# Canterbury Area of High Landscape Value Review of Local Plan Inspector's Comments

Job Number 12601 20 December 2005

Review of Local Plan Inspector's Comments

**Figure 1**  
**Inspector's Visual Envelope**

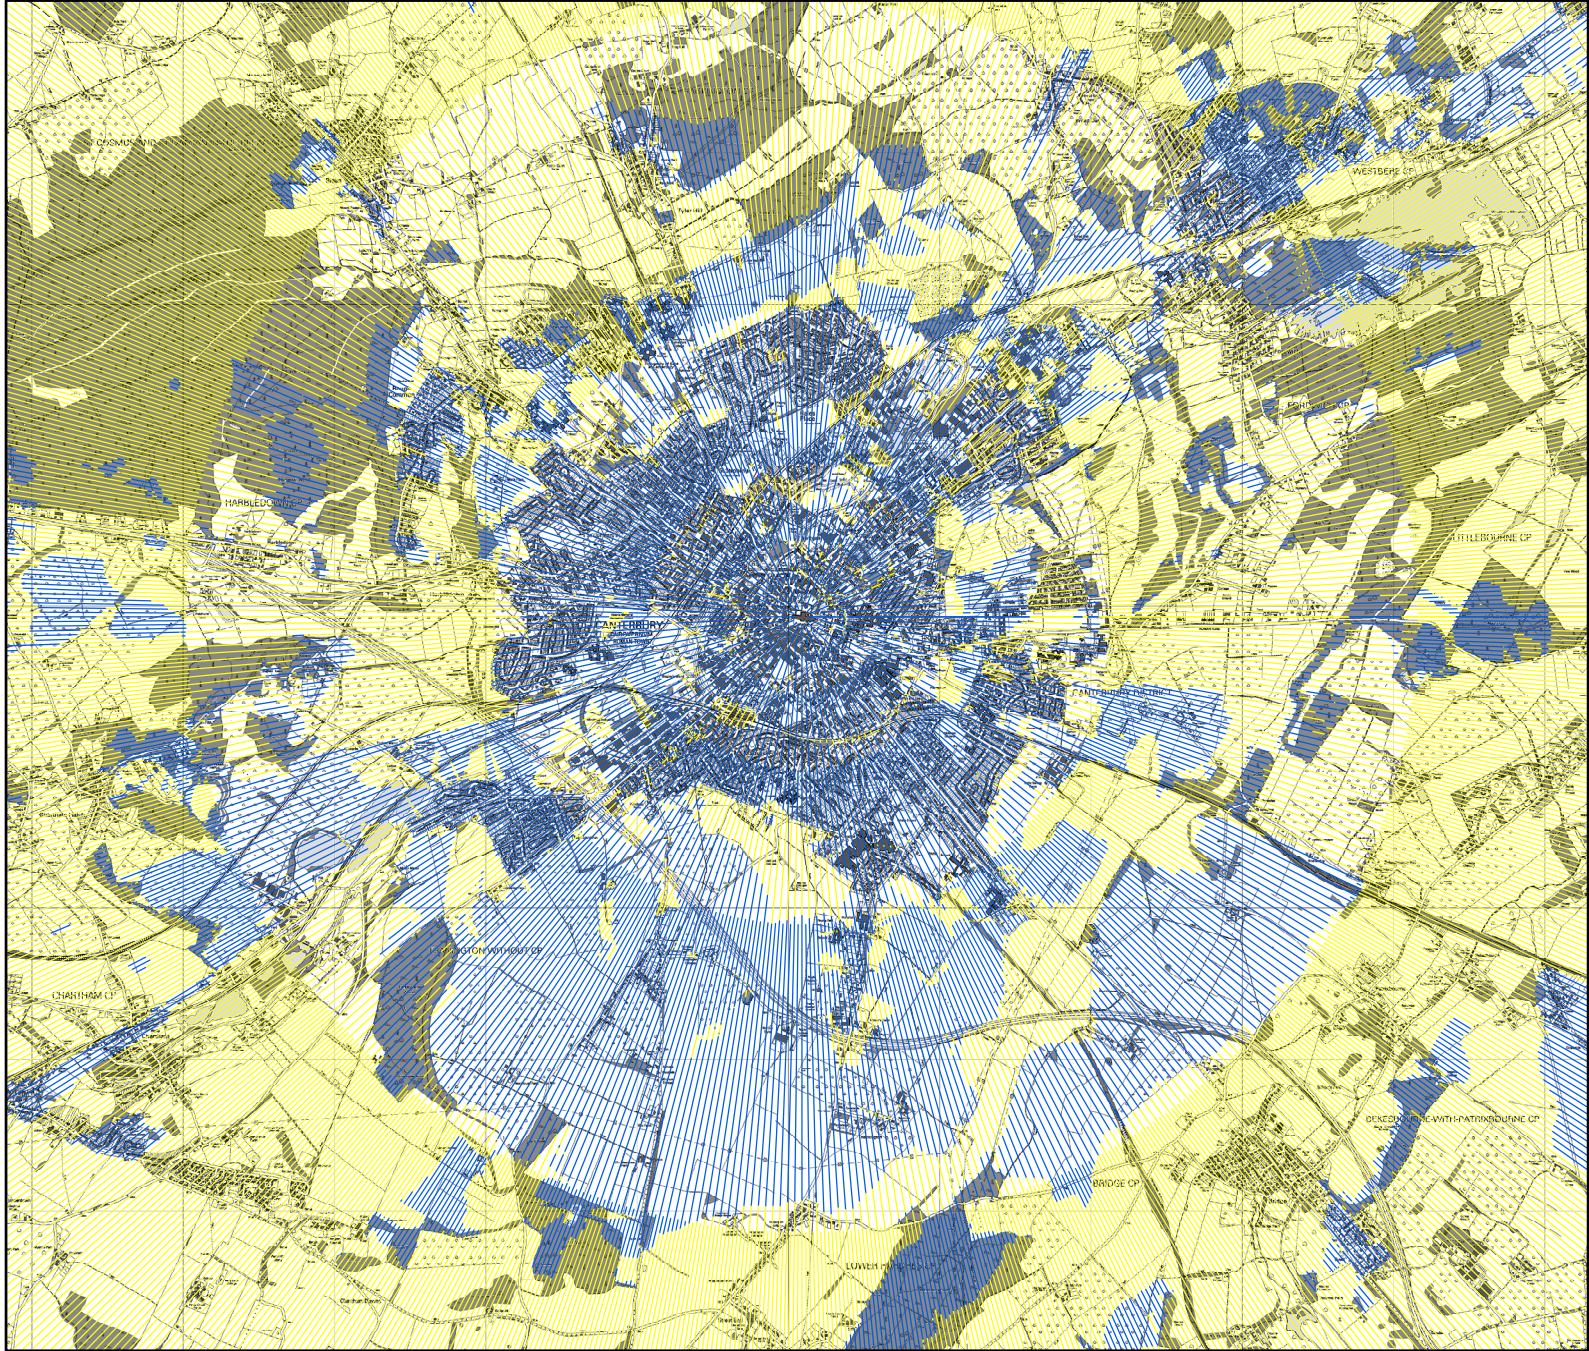
3.1 The Inspector's VEM provides a picture of what is visible from Bell Harry derived from an input of data based on visually blocking elements.

3.2 It covers a similar extent to the original VEM in that it is largely defined by the topography of the valley. However it is evident that large blocks of woodland, and substantial built fabric, such as the commercial buildings in the Sturry area, have an impact on views out.

- Overall the outer extent is similar but internally the effect is more patchy.
- The southern outer boundary is largely unchanged.
- The northern outer boundary is tighter in the University of Kent area – generally following the road/Park Wood.
- The northeast outer boundary is tighter and Broad Oak is generally excluded as the woodland blocks between it and the city take effect.
- To the east and west – Old Park and Bigbury Hill show a mosaic of views depending on the presence/absence of vegetation.

**Figure 2**  
**Recommended amendments to**  
**Area of High Landscape Value**

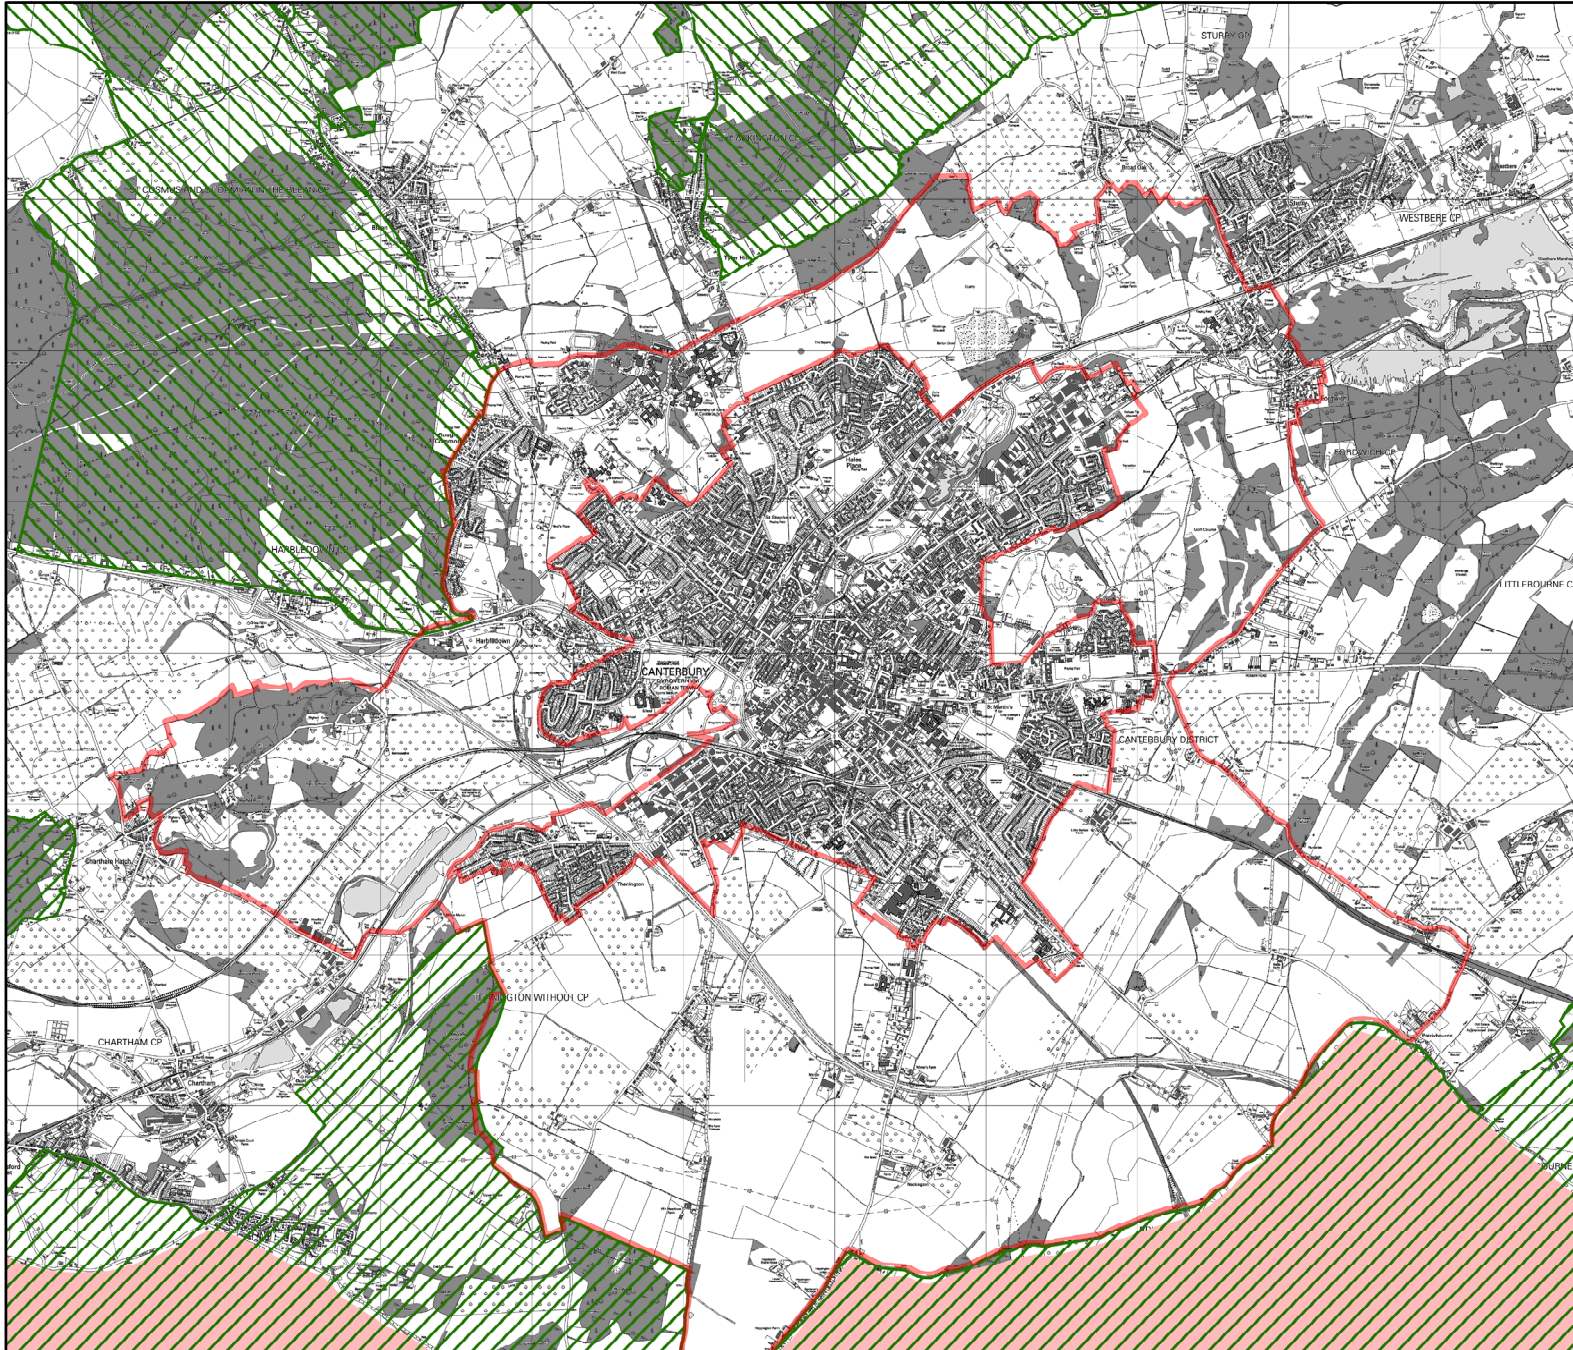
- 5.11 Along the northern boundary there is scope for some amendment. The land rises steeply to the University of Kent campus and then plateaus before dropping to the Sarre Penn Valley beyond. The Inspector's VEM and cathedral visit show that only the southern edge of the plateau is visible, partly blocked by woodland and the massing of the existing University buildings. It is therefore recommended that the AHLV boundary is revised to follow the line shown on Figure 2, generally following the road network and southern edge of the woodland blocks.

- 5.12 It is then recommended that the boundary follows the ridge line road across Tyler Hill as shown in the original AHLV designation, but terminates to the east of the woodland blocks that separate Broad Oak from the Canterbury area. In effect this means the orchards to the west and south of Broad Oak are removed from the

designation. The lower slopes should stay within the AHLV area as they form part of the long views out of the city to the northeast. It is recommended that the blocks of woodland themselves, including Dengrove Wood, are included within the designation area as substantial parts of them are visible from Bell Harry Tower due to the landform. This would also afford them greater protection which in turn would help to maintain their blocking function.

It is recommended that the AHLV designation be amended to that shown on Figure 2 on the following basis:

- There is no change to the outer southern boundary.
- Whilst there is reduced visibility at Bigbury Hill and Old Park the directness and quality of the views that exist, combined with their cultural and ecological value, require them to be included in the AHLV.
- The effect of blocking features, most notably woodland, requires that the northern boundary be amended at the University of Kent and Broad Oak.
